<b>Subject:</b> <b>ROUGH IDLE, LACK OF POWER, AND/OR MIL ON WITH DTC P2177/P2187 (FUEL SYSTEM LEAN)</b>	<b>Bulletin No:</b> 01-022/08 <b>Last Issued:</b> 04/02/2008
--	---

This bulletin supersedes the previous bulletin issued on 03/27/08. The REPAIR PROCEDURE has been revised.

## APPLICABLE MODEL(S)/VINS

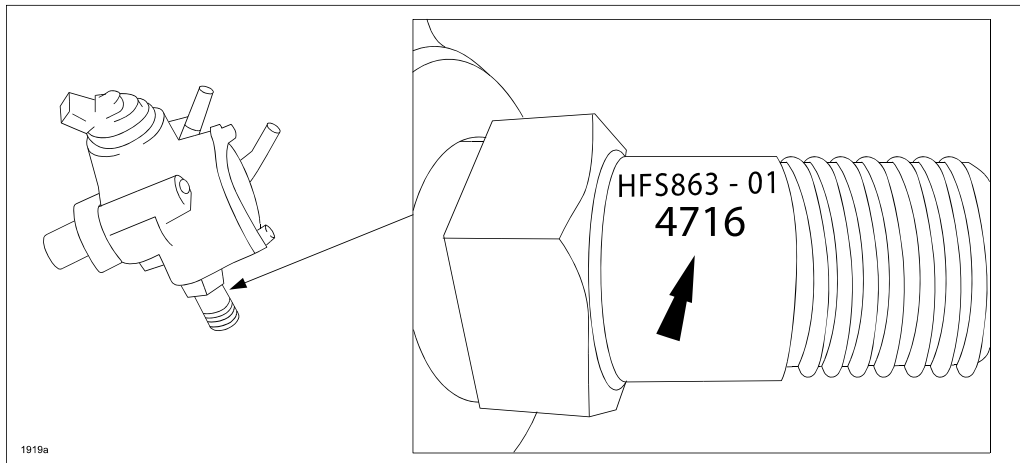
This is caused by a delayed fuel pressure build-up from the high pressure fuel pump. There are two main reasons for this:

1. The drive current from the PCM is not enough for some fuel pumps.
2. Some fuel pumps have slower response.

To fix the problem, the PCM software and the specification of the high-pressure fuel pump have been changed. Customers having this concern should have their vehicle repaired using the following repair procedure.

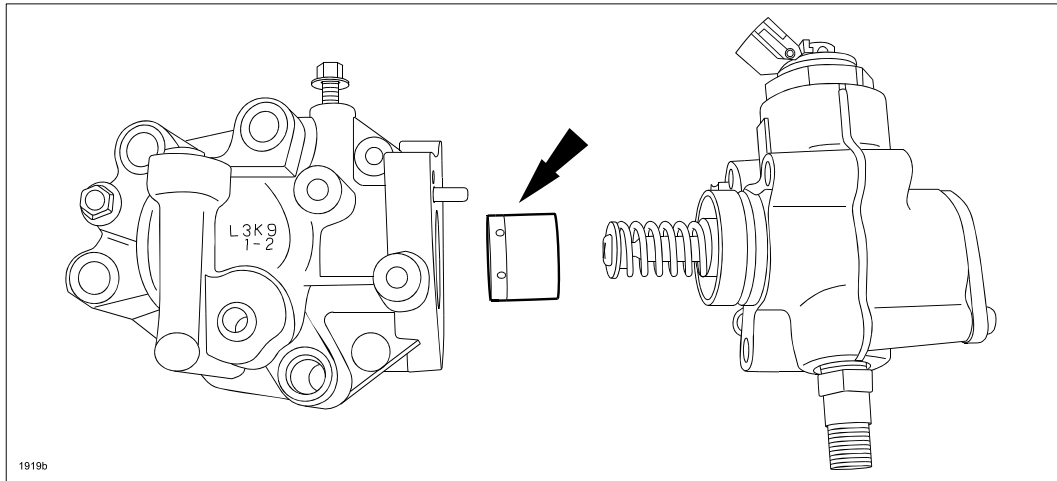
- If the history indicates part number L3K9-13-35ZB was used during a repair, use the following illustration to inspect the production date of the high-pressure fuel pump. Replace it if the production date is before March 26, 2007.

Date of production is marked as a 4 digit code “YMDD” at the pipe.

Y for Year	4 for 2004....7 for 2007
M for Month	1 for Jan....9 for Sept, X for October, Y for Nov, Z for Dec
DD for Date	01 for 1st of month....31 for 31st of month
Example	“4Z16” means Dec 16, 2004; 7608 means June 8, 2007

**CAUTION:** When replacing the high-pressure fuel pump, it is very important to make sure that the tension collar is present before reinstalling the pump. Failure to do so will result in excessive engine noise and the subsequent failure of the high-pressure fuel pump and its cam lobes.
